Project	IEEE 802.16 Broadband Wireless Access Working Group < http://ieee802.org/16 >	
Title	Proposal on change in ARQ	
Date Submitted	2003-09-06	
Source(s)	Vladimir Yanover Tal Kaitz Naftali Chayat Marianna Goldhammer Lei Wang Ofel Kelman Radu Selea Robert Nelson Roger Eline Baraa Al Dabagh Itzik Kitroser	Alvarion mailto:vladimir.yanover@alvarion.com Alvarion tal.kaitz@alvarion.com Alvarion naftali.chayat@alvarion.com Alvarion marianna.goldhammer@alvarion.com Wi-Lan LeiW@Wi-LAN.com Airspan okelman@Airspan.com Redline Comm. Radu@redlinecommunications.com MacPhyModems bob_nelson@ieee.org Intel roger.j.eline@intel.com Intel baraa.al.dabagh@intel.com Runcom itzikk@runcom.co.il
Re:	It is a response to IEEE 802.16 Working Group Recirculation Ballot #11b Announcement (IEEE 802.16-03/38)	
Abstract	The document contains supporting material for the comment to P802.16d/D3 in the part of ARQ implementation

Proposal on change in ARQ

2. Specific changes in IEEE P802.16d/D3

Figure NNN.—Block usage examples for ARQ transmissions and retransmissions

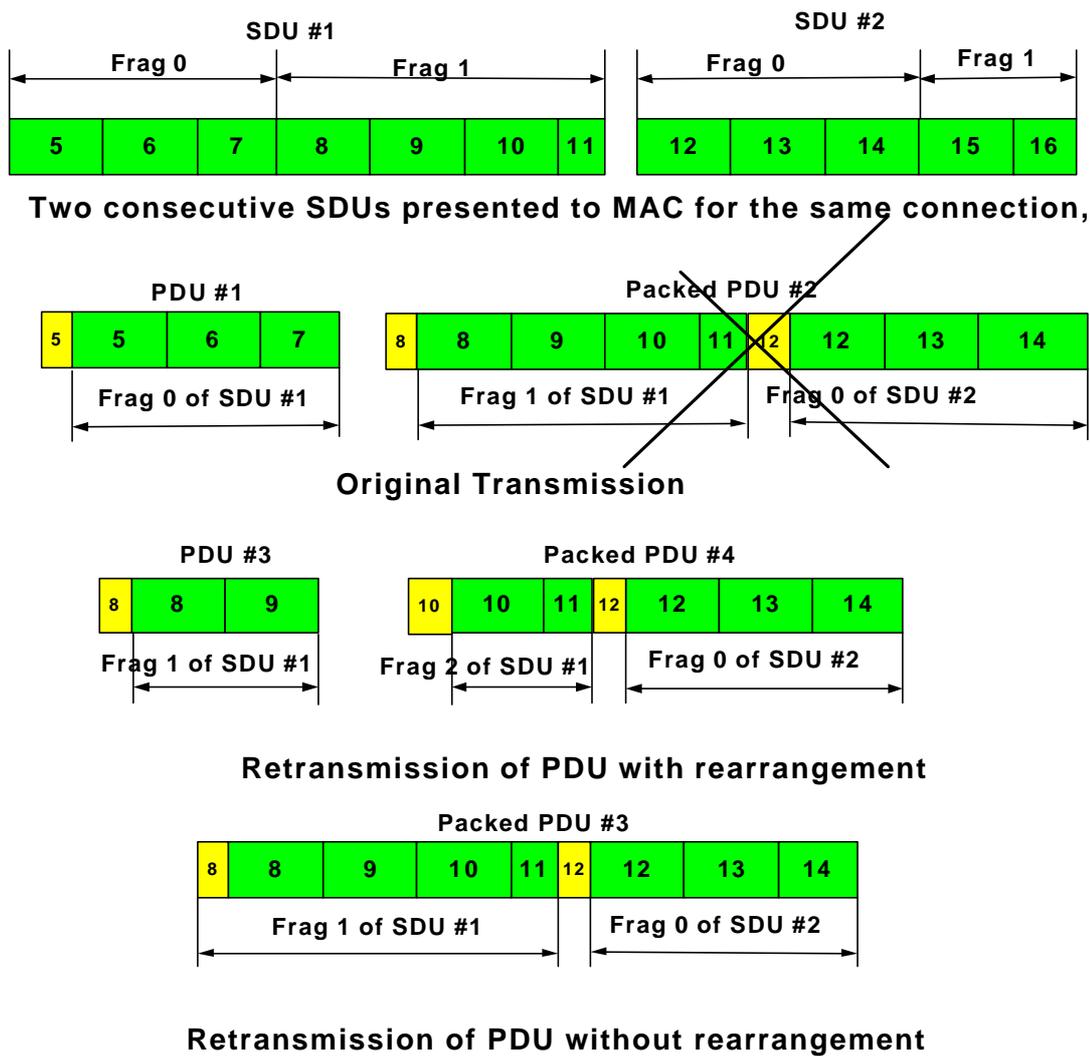
If ARQ is enabled at the connection, Fragmentation and Packing sub-headers contain a BSN, which is the sequence number of the first ARQ block in the sequence of blocks following this sub-header. It is a matter of transmitter's policy whether a set of blocks once transmitted as a single PDU should be retransmitted also as a single PDU or not. Figure NNN illustrates the use of blocks for ARQ transmissions and retransmissions; two options for retransmission presented: with and without rearrangements of blocks.

Figure 34: Transmitter ARQ state machine

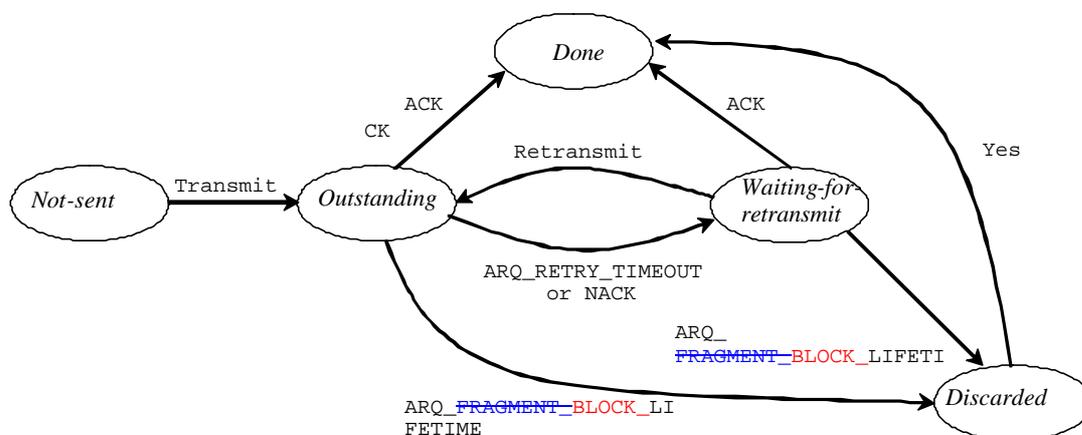
where a single MAC PDU would not normally have two consecutive fragments from the same MAC SDU, this is likely for ARQ-enabled connections, since such fragmentation can facilitate retransmission. The MAC SDU fragment structure shall be maintained for retransmissions. An ARQ fragment block may be in one of the following four states, not-sent, outstanding, discarded and waiting-for-retransmission. Any ARQ fragment block begins as not-sent. After it is sent it becomes outstanding for a period of time termed ACK_RETRY_TIMEOUT. While a fragment block is in outstanding state, it either is acknowledged and discarded, or transitions to waiting-for-retransmission after ACK_RETRY_TIMEOUT or NACK. An ARQ fragment block can become waiting-for-retransmission before the ACK_RETRY_TIMEOUT period expires if it is negatively acknowledged. An ARQ fragment block may also change from waiting-for-retransmission to discarded when an ACK message for it is received or after a timeout ARQ_FRAGMENT_LIFETIME. For a given connection the transmitter shall first handle (transmit or discard) fragment block in 'waiting-for-retransmission' state and only then fragment block in 'non-sent' state. Fragments Blocks in 'outstanding' or 'discarded' state shall not be transmitted. When fragments blocks are retransmitted, the fragment with the lowest FSN BSN shall be retransmitted first. The ARQ transmit fragment block state sequence is shown in Figure 34.

Figure 37 - ARQ fragment block reception

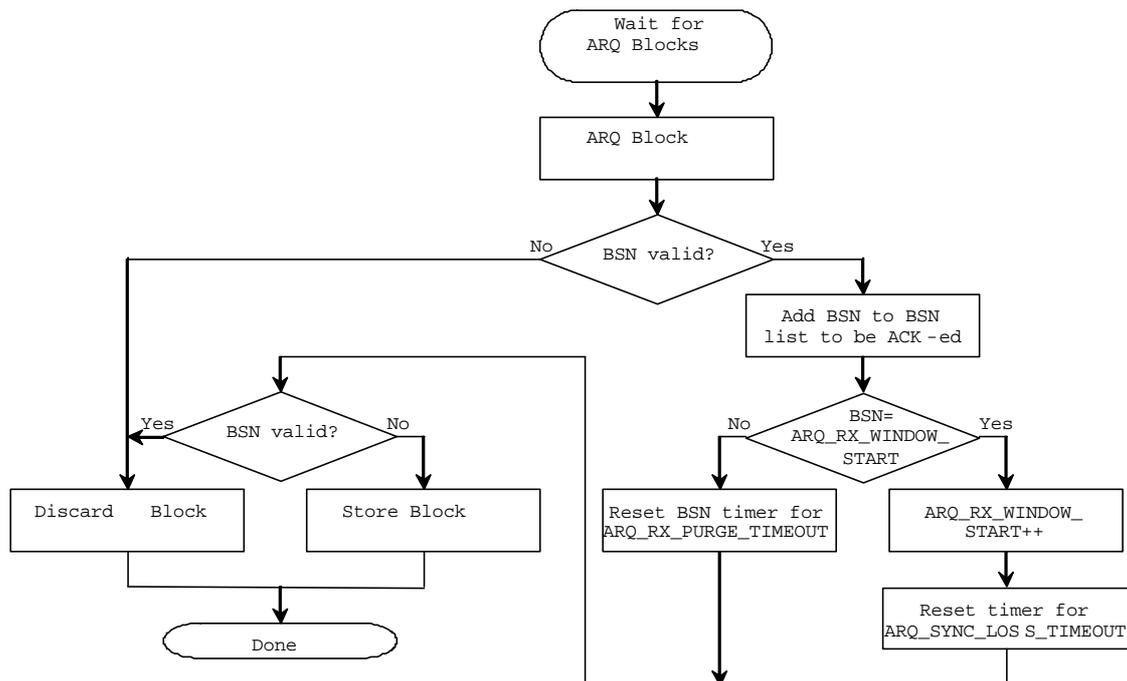
When a PDU is received, its integrity is determined based on the CRC-32 checksum. If a PDU passes the checksum, it is unpacked and de-fragmented, if necessary. The receiver maintains a sliding-window defined by ARQ_RX_WINDOW_START state variable and the ARQ_WINDOW_SIZE parameter. When an ARQ fragment block with a number that falls in the range defined by the sliding window is received, the receiver shall accept it. ARQ fragment block numbers outside the sliding window shall be rejected as out of order. The

receiver should discard duplicate ARQ **fragments blocks** (i.e. ARQ **fragments blocks** that were already received correctly) within the window.
